IEEE P802.11

Wireless Access Method and Physical Layer Specification

Authentication Letter Ballot comments

**Wim Diepstraten
AT&T WCND
Nieuwegein
The Netherlands**

Shared Key Authentication:

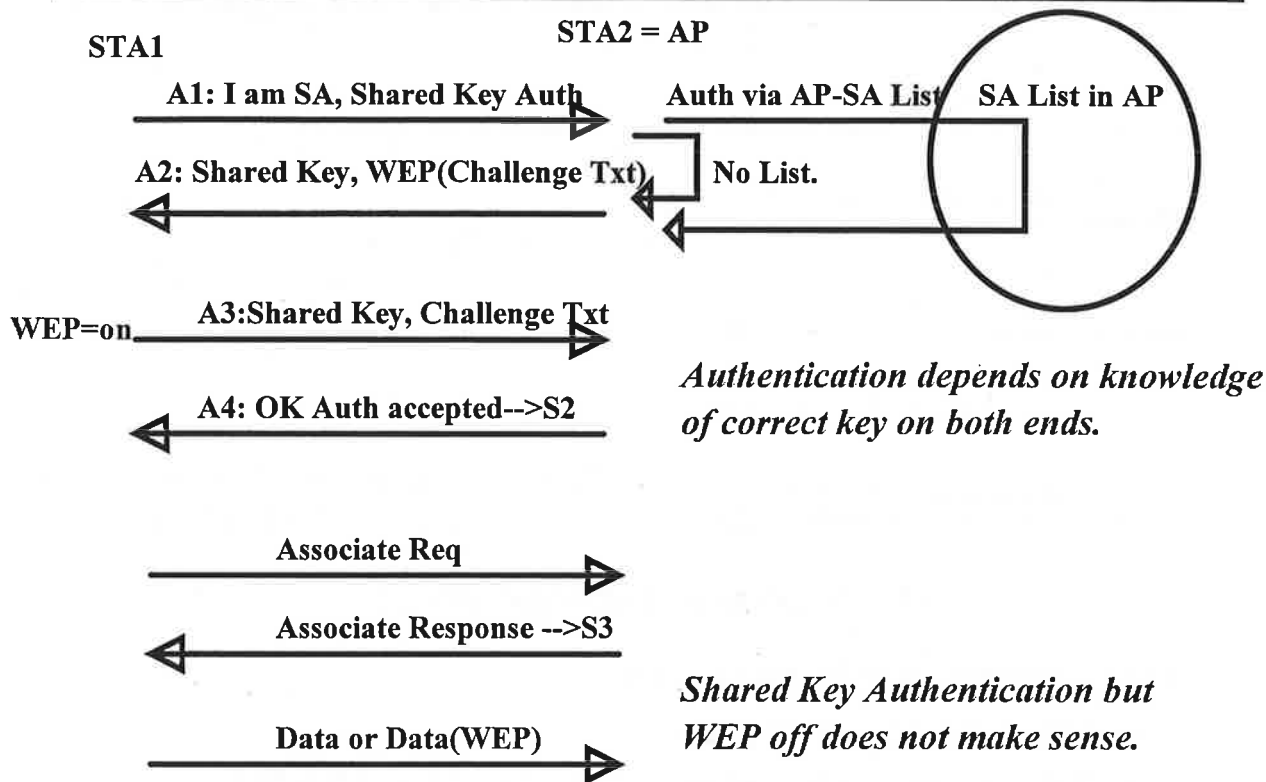
- Shared Key Authentication:
 - Needs WEP algorithm + Shared Key in Authentication phase.
 - » The same key is used for Privacy and Authentication (no separate key provisions in MIB).
 - AP can do an additional membership check against SA list.
 - Using Shared Key Authentication, without using WEP for data privacy does not make sense from privacy point of view. (We are not doing security but privacy).
- So Shared Key Authentication does also rely on knowledge of the same key on both ends.
- What is the value of Shared Key versus Open System Authentication when WEP is on???????
- So why bother?

Conclusion: Shared Key authentication is equivalent to Open System authentication, because they both depend on the knowledge of the same key on both ends.

Recommendation: Delete Shared Key Authentication method.

Proprietary Authentication:

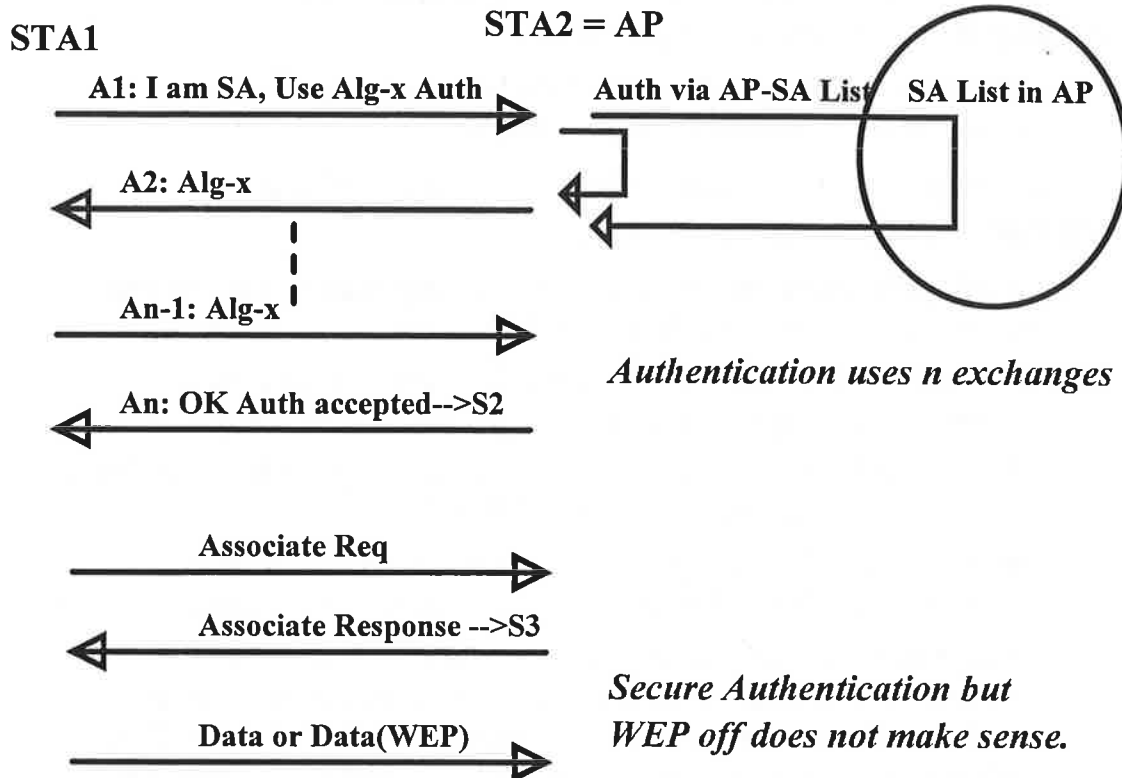
- Proprietary algorithm possible.
 - Can take relative long time depending on algorithm.
 - Therefore desire for pre-authentication possibility.
 - Station can be authenticated with multiple APs and Stations at the same time according to current scheme.
 - » This is basic requirement to allow pre-authentication.
- There is a desire for support of other authentication methods.
 - This is provided by the mechanism as currently defined.
 - Although from a privacy point of view it does not provide additional protection when the WEP key is known.
